Attachment G
Exceptions to Design Standards

Fact Sheet Exceptions to Mandatory Design Standards

LAUREN PROCTOR, Registered Civil Engineer
CH2M HILL

**MANDATORY EXCEPTION NO.1D
 SUPERELEVATION = 6%, LESS
 THAN 10% STANDARD SUPERELEVATION**

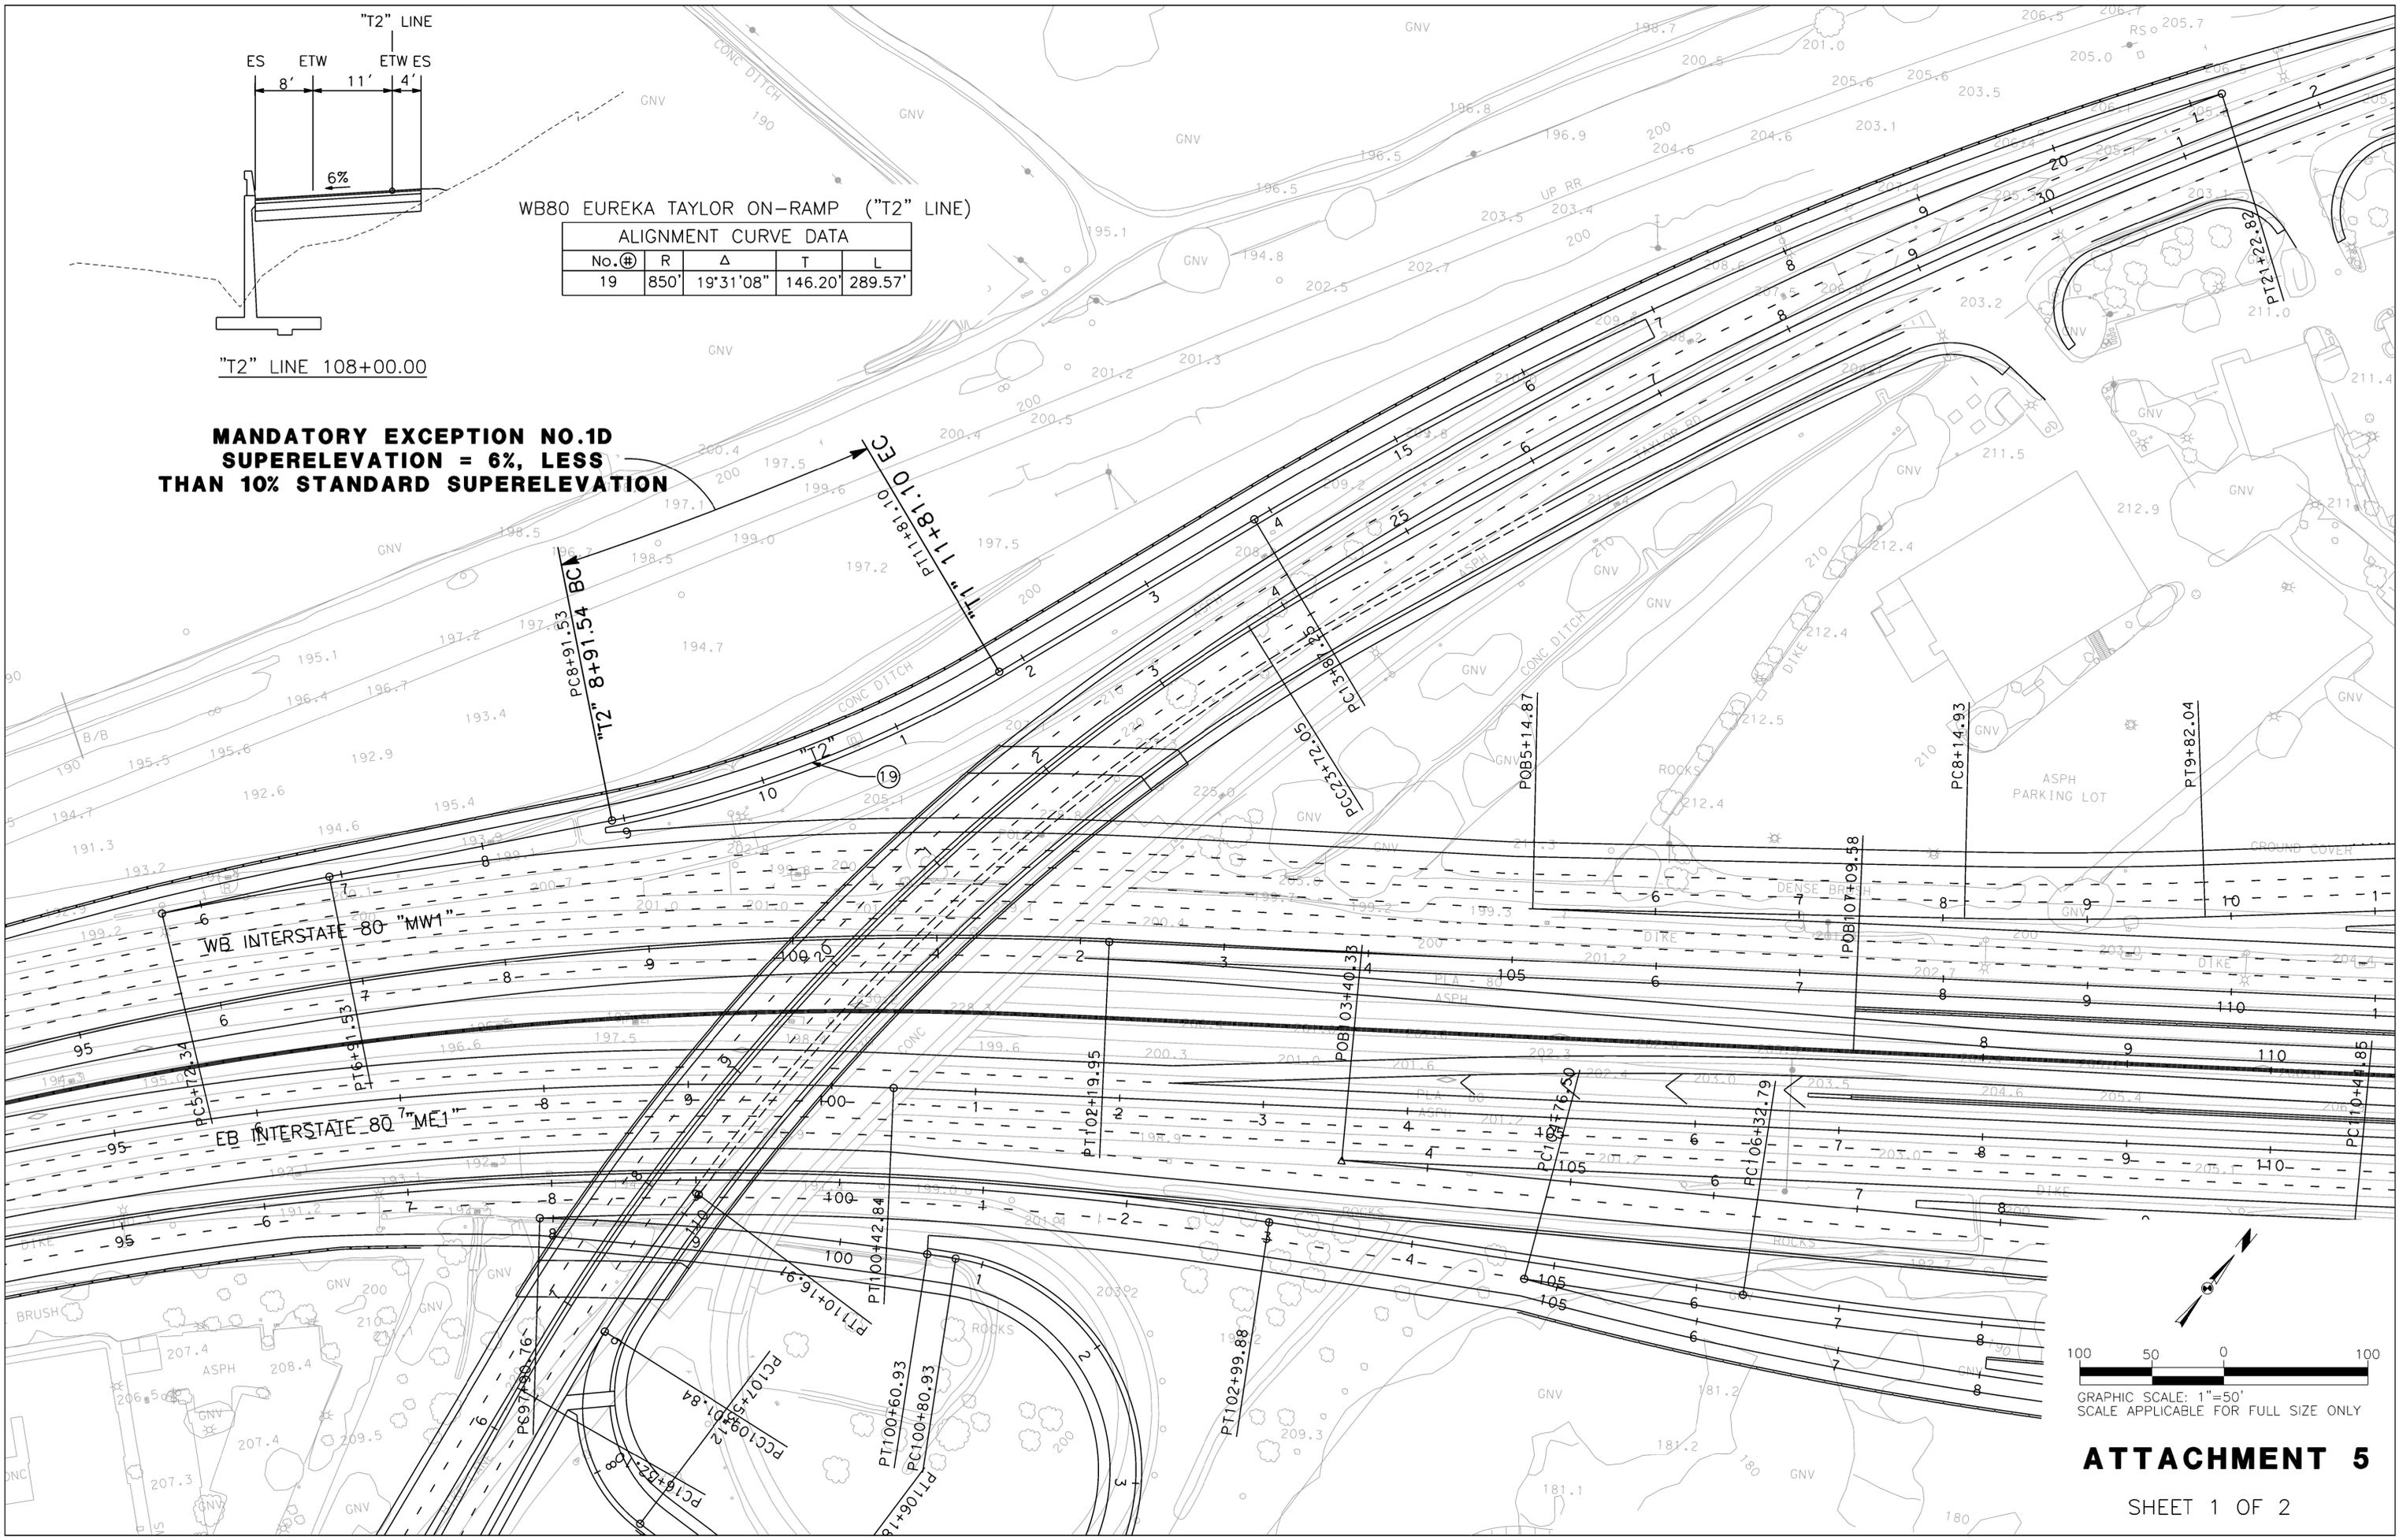
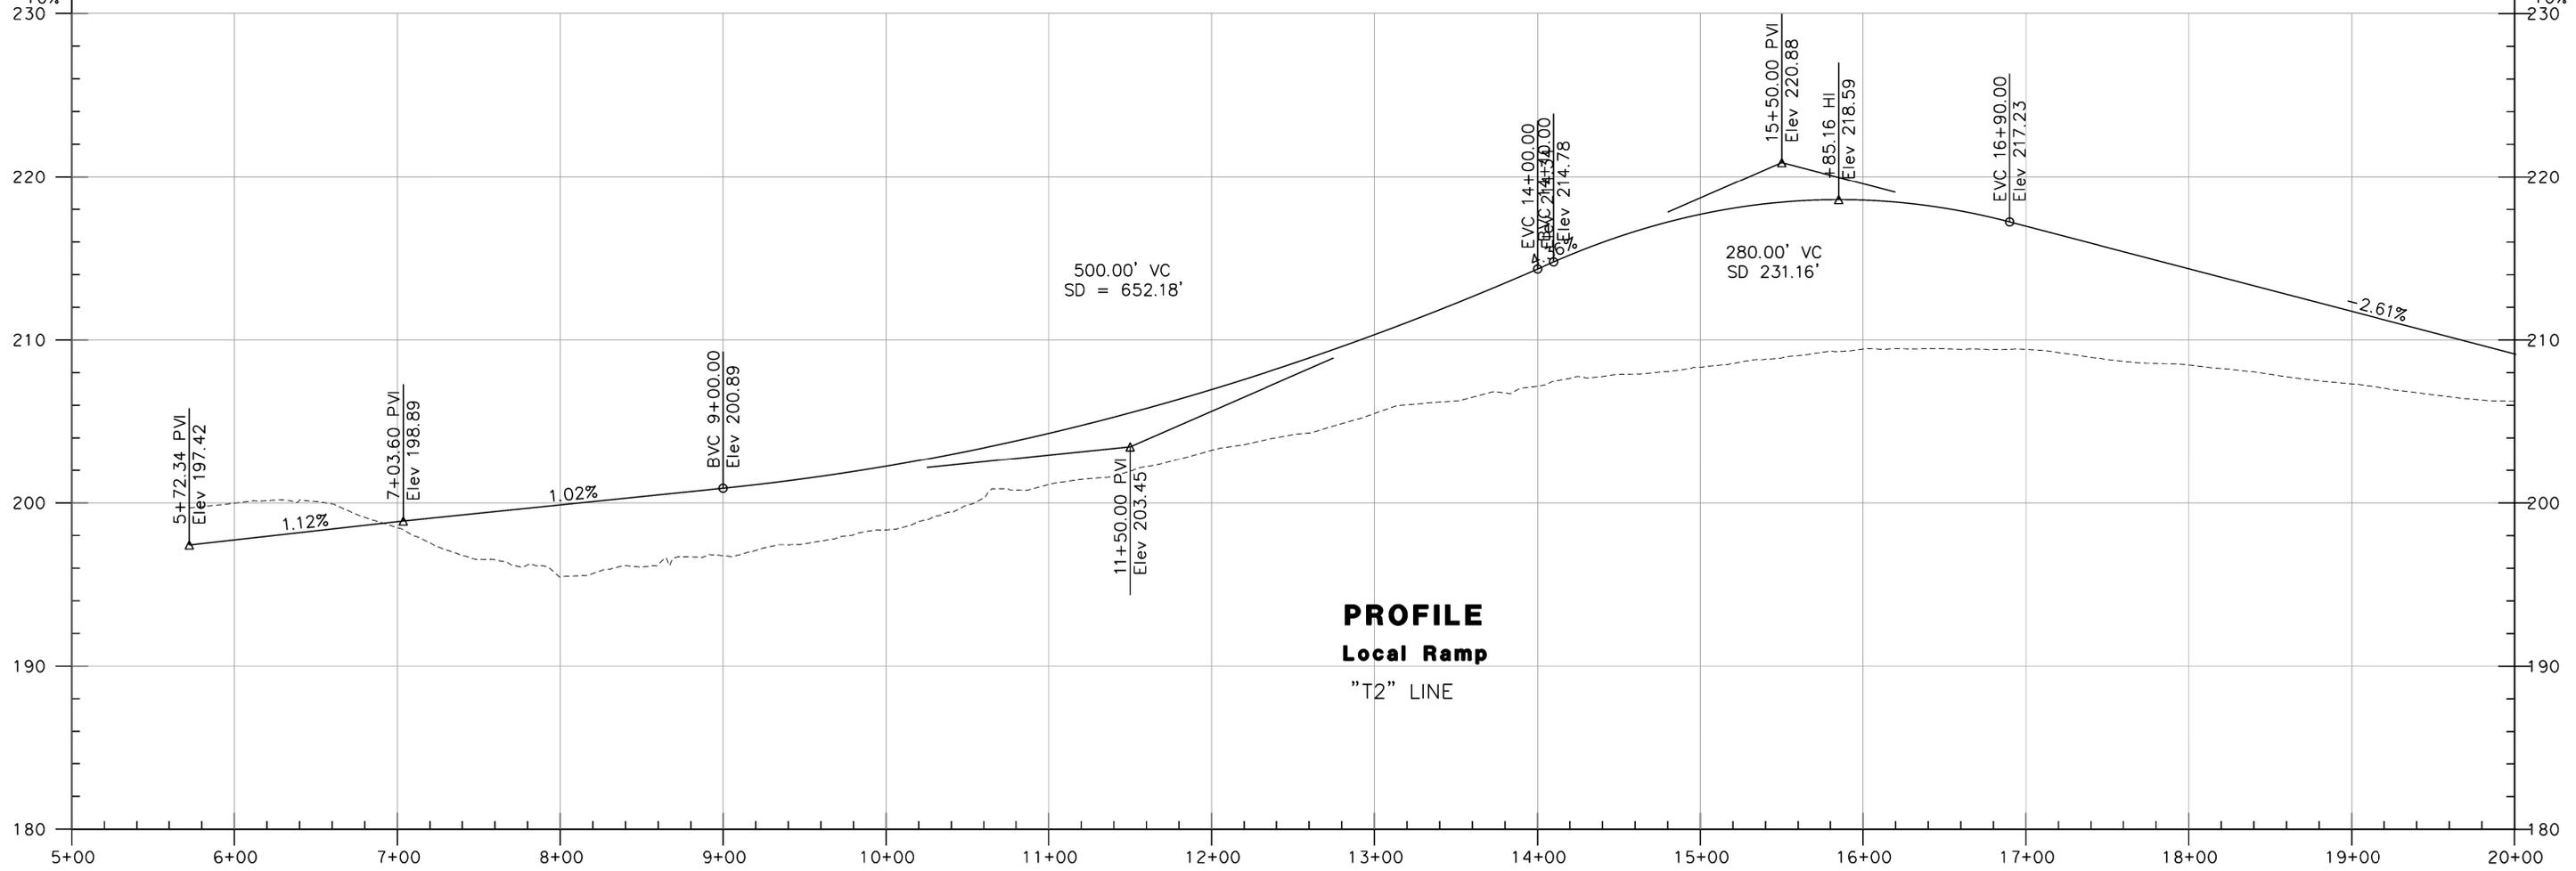
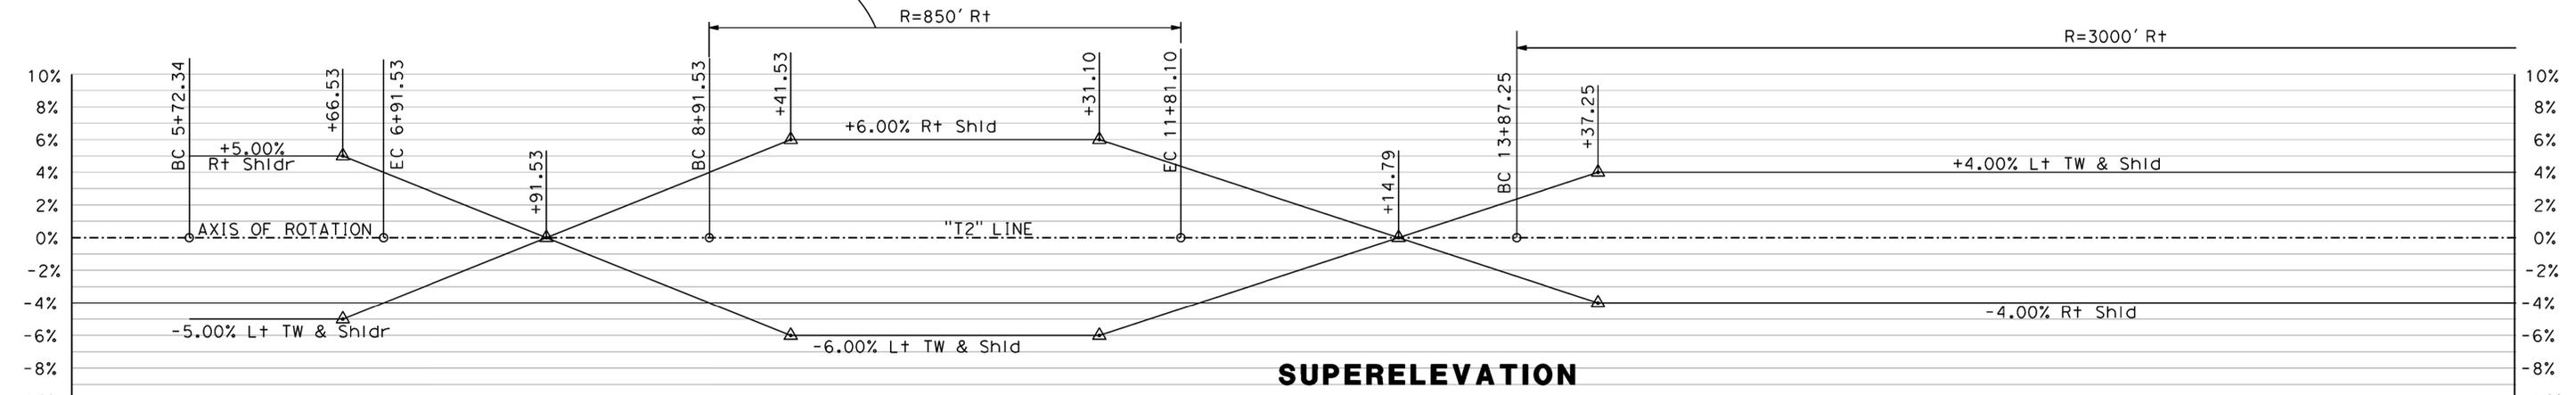
Location D: Taylor WB on-ramp, “T2” station 8+91.54 to 11+81.10, the proposed 850' curve will have superelevation rate of 6%. (See Attachment 5)

The standard superelevation required for 850' curve is 10%.

Location D: The reason for the design exception for location D is due to the mainline I-80 sloping to the opposite direction and a 10% superelevation rate would create a grade break of greater than 10% at the gore. A higher superelevation rate would require an alignment with a longer tangent and a physical gore area shifted further west to accommodate superelevation runoff and avoid a grade break across the gore of greater than 10%. It would also shorten the weaving length available the Atlantic Street off-ramp. Due to the location being immediately adjacent and parallel to UPRR on the north side, all improvement to conform to full standard would have to be to the south side of I-80.

The proposed design with a non-standard feature will still meet the 50 mph design speed at inlet nose based on comfortable speed. The maximum comfortable speed based on the proposed design with 6% superelevation rate is 52 mph.

Conformance to standard would require realignment of I-80 to the south, including:

ATTACHMENT 6

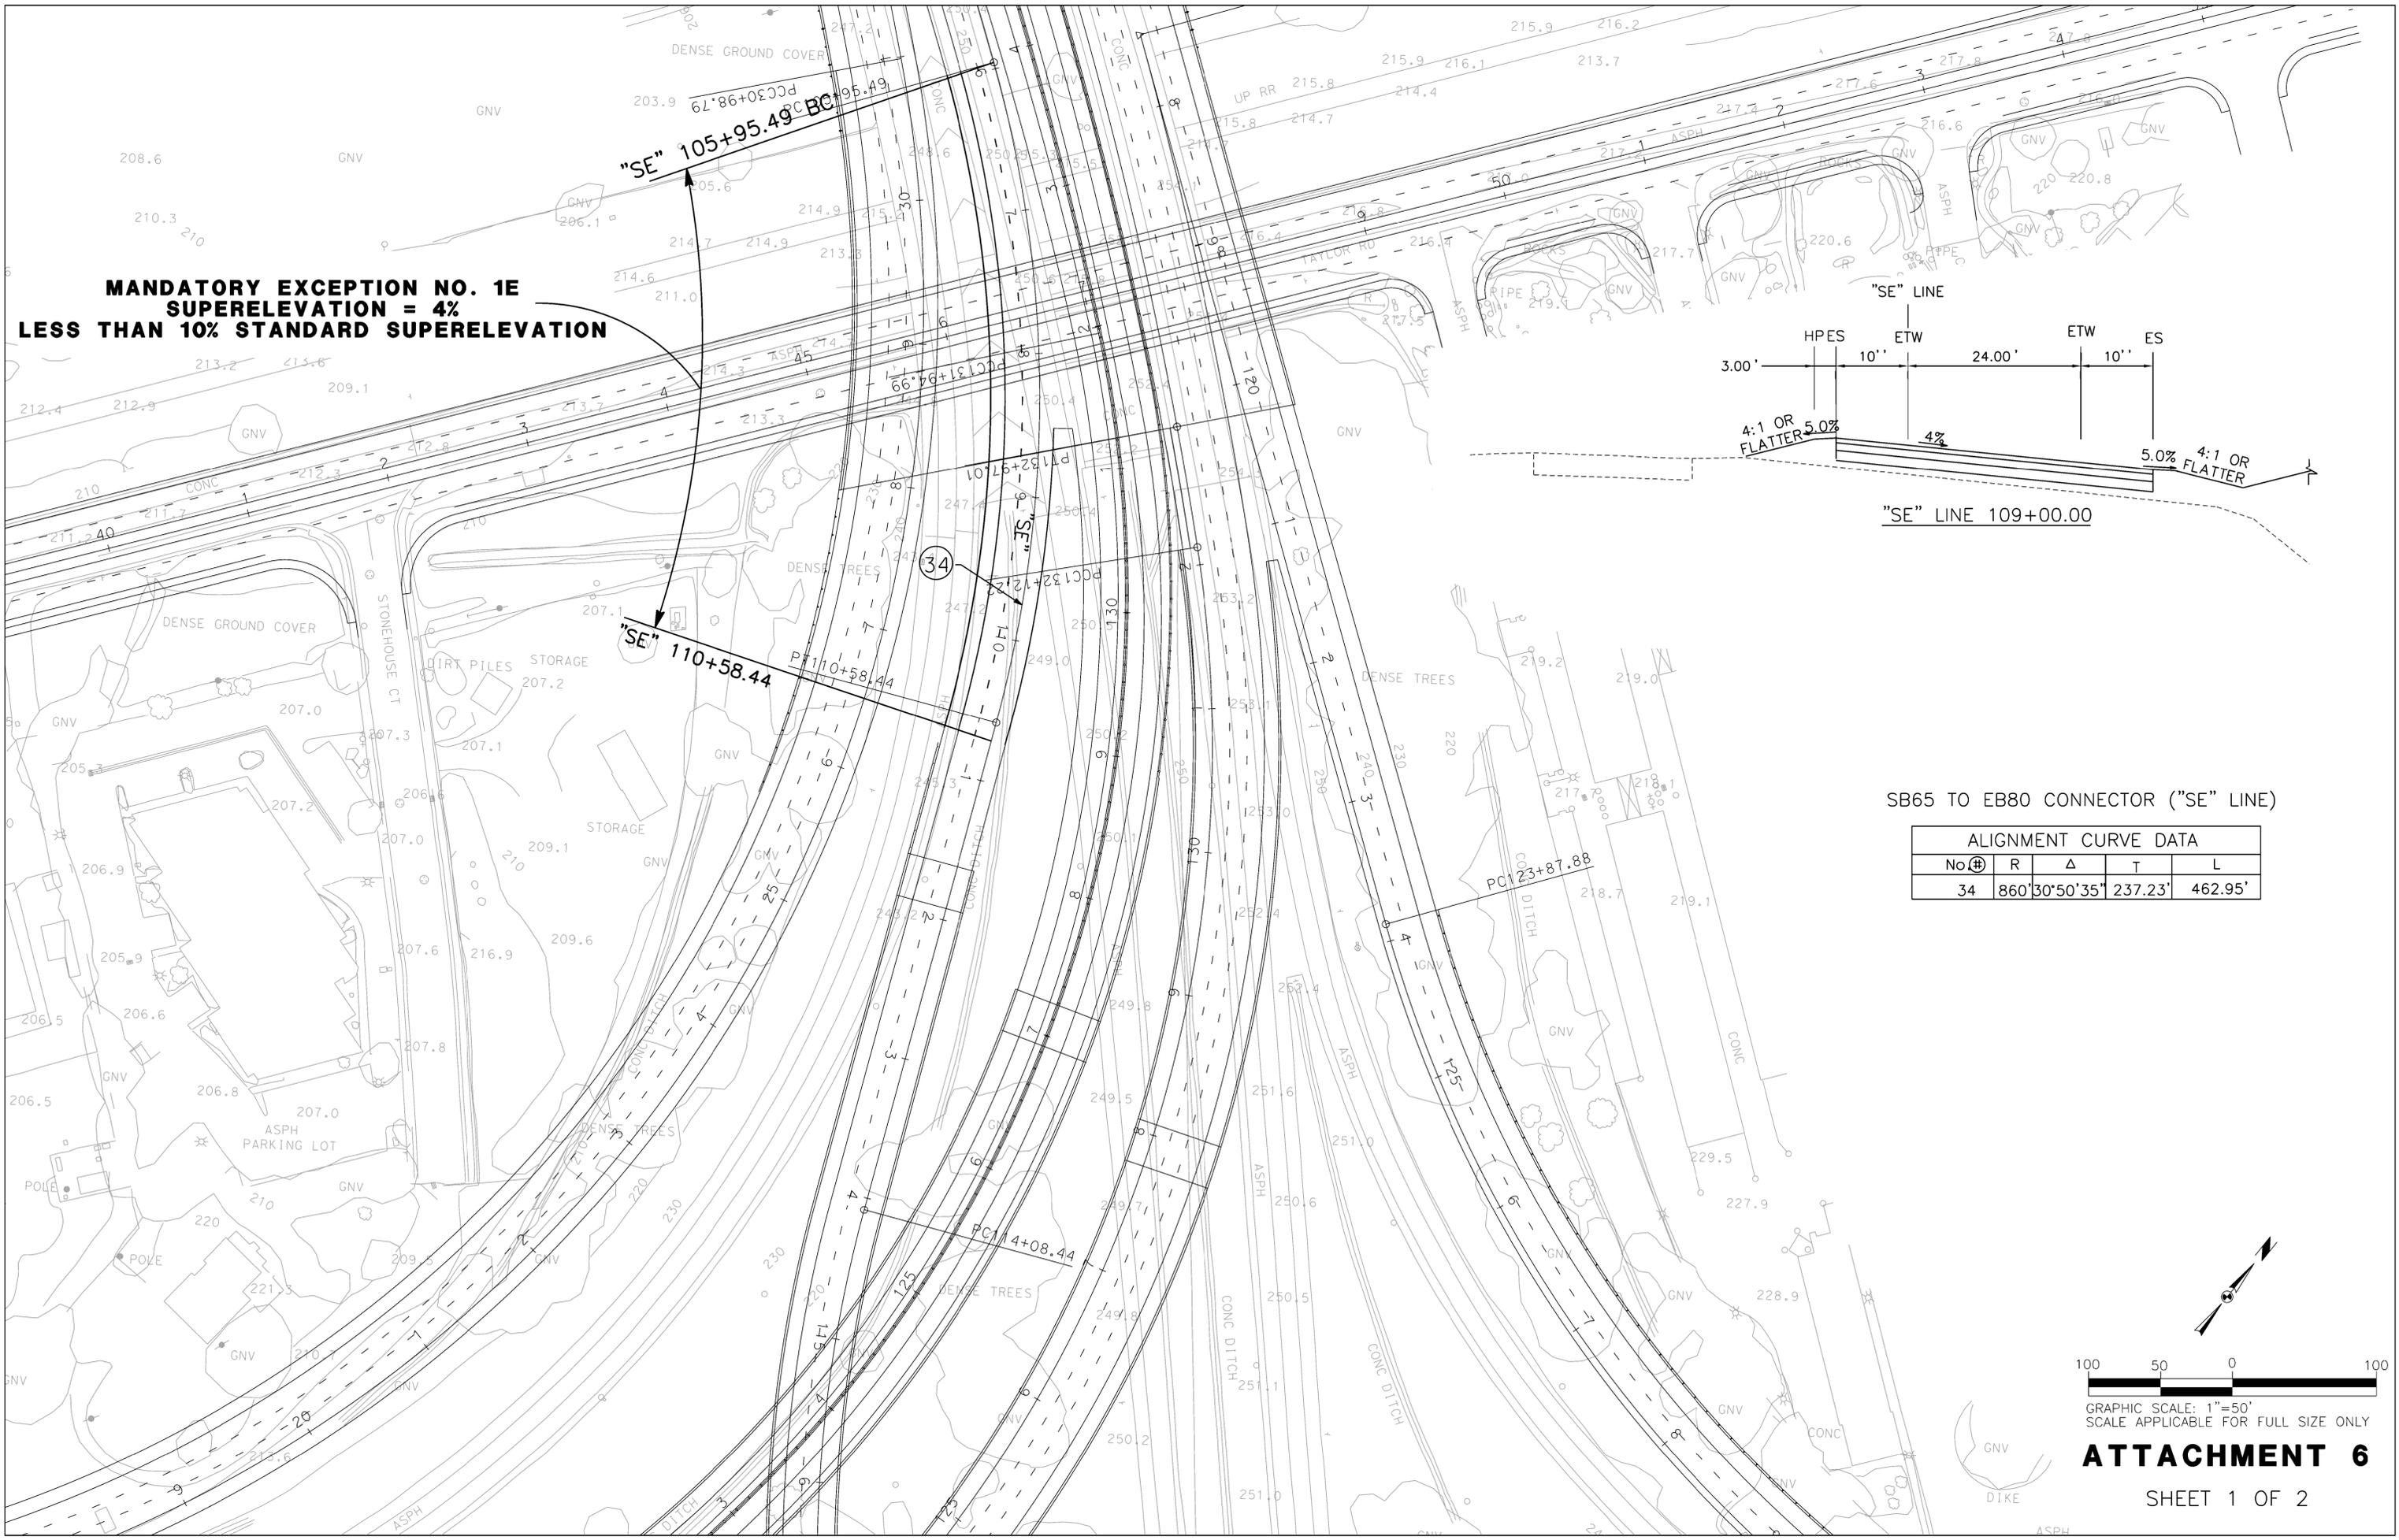
Location E: SR 65 SB to I-80 EB Connector, “SE” station 105+95.49 to 110+58.44, the proposed 860' curve will have superelevation rate of 4%. (See Attachment 6)

The standard superelevation required for 860' curve is 10%.

**MANDATORY EXCEPTION NO. 1E
 SUPERELEVATION = 4%
 LESS THAN 10% STANDARD SUPERELEVATION**

Location E: The reason for the design exception for location B is to match the 4% slope of East Roseville Viaduct. The Viaduct has a minimum clearance required over UPRR.

The proposed design with a non-standard feature will still meet the 45 mph design speed based on comfortable speed. The maximum comfortable speed based on the proposed design with 4% superelevation rate is 49 mph.

Conformance to standard would require changing the profile of SR 65 to increase the finish elevation by approximately 6 feet at Viaduct. A 2100' length of existing viaduct will need to be replaced along with reconstruction 300' of roadway to conform.
